Technical News Bulletin

Emhart Glass Releases A New Stepper Motor Drive, Replacement Kit. # 27533A For Veritas iB

Veritas iB Stepper Motor Control Panel

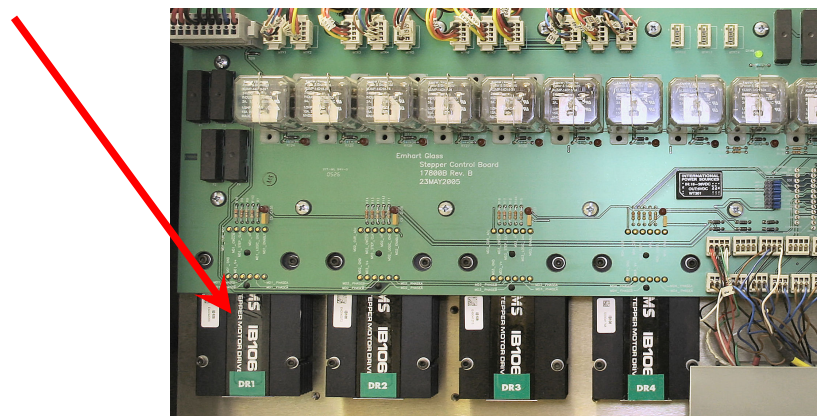
Due to part obsolescence, the IB106 Stepper Driver (12706P) for the Veritas iB belt handler will no longer be available and will be replaced with update kit # 27533A when needed.

Installation of the parts in the new kit was designed to be simple and does not require Emhart Glass service personnel to do the installation. To install, the adapter plate mounts directly to existing holes in the back panel and the pins on the printed circuit board plug directly into the 17800 stepper control board. Detailed mounting instructions for installation of the new replacement parts will be included in each kit.

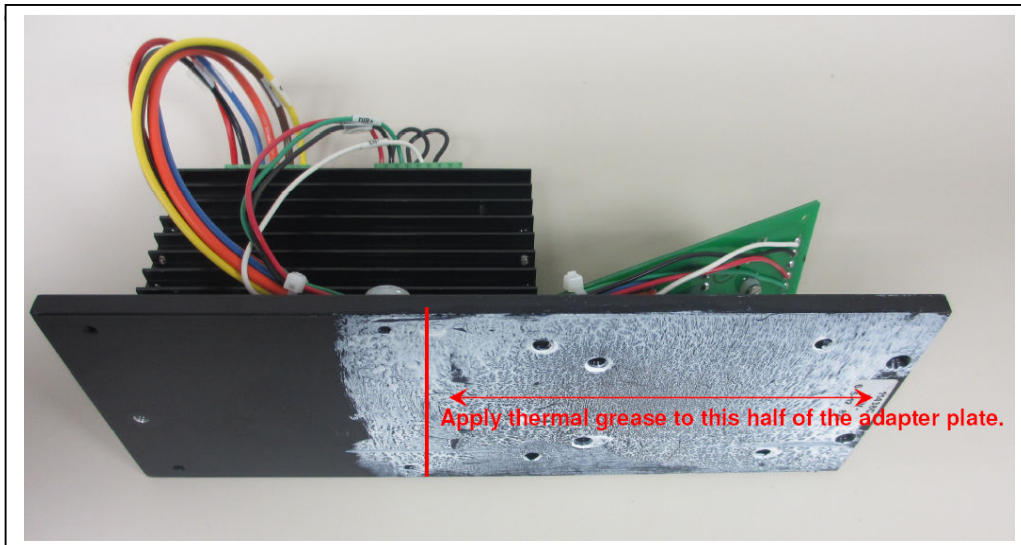
Stepper Motor Replacement Kit #27533A Includes:

Qty. 1 - Configured Stepper Drive Part # 21817B

Qty. 1 - Adapter cable and PCB

Qty. 1 - Adapter Plate
